PREVOST

**WARRANTY
BULLETIN**

WB13-29

DATE :	MAY 2013	SECTION :	05 - Cooling
EXPIRATION:	MAY 2015		
SUBJECT :	LOOSENING BOLT ISSUE - COOLING FAN CLUTCH TRIPOD

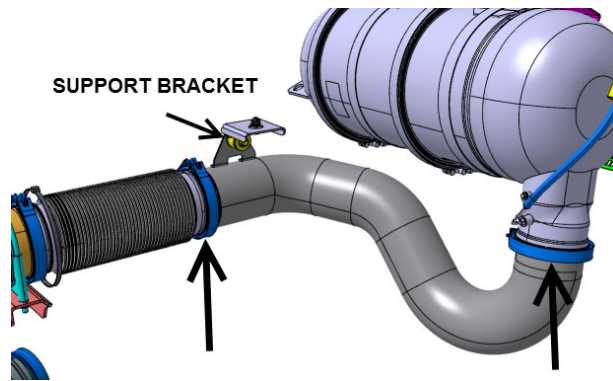
b. Undo the two (2) V-band clamps identified on the image.

c. Unscrew the nut at the support bracket.

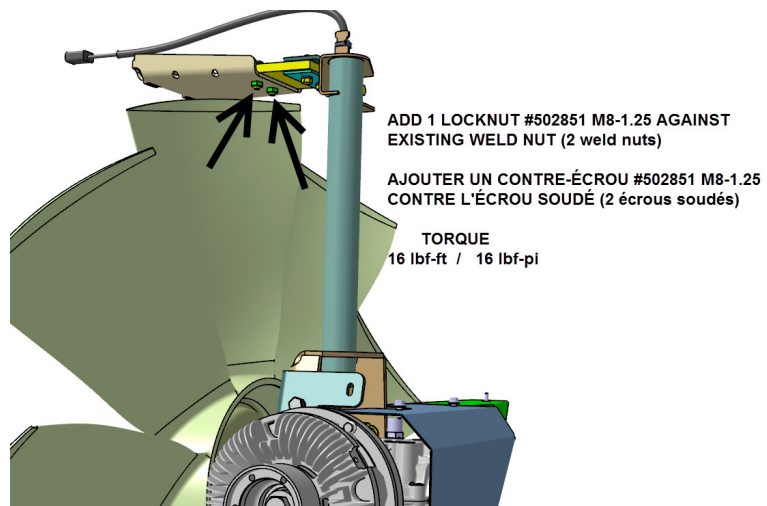
4. **ALL TYPES.** Add two locknuts #502851 as described on the image at right. **If needed, tighten the bolt a little bit more to show more threads.**

5. **ALL TYPES.** Add two locknuts #502851 as described on the image at right. **If needed, tighten the bolt a little bit more to show more threads.**

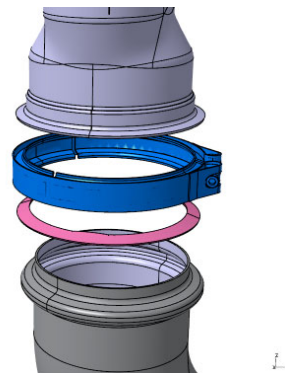
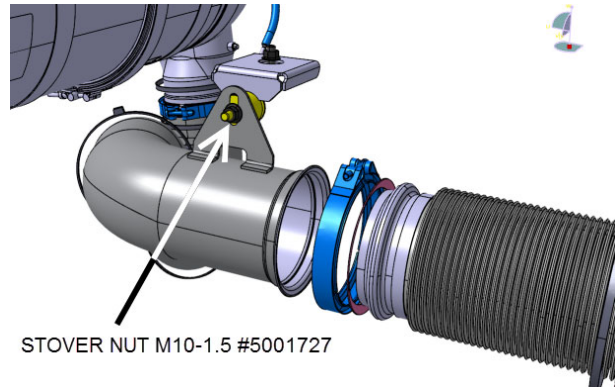
6. **H3 VIP CONVERSION SHELLS.** Reinstall the exhaust pipe.

- 2 new exhaust gasket #21095726
- 2 new V-band clamps #21021850 (torque 100 lbf-inch)
- 1 new Stover nut M10-1.5 #5001727 (torque 32 lbf-ft)
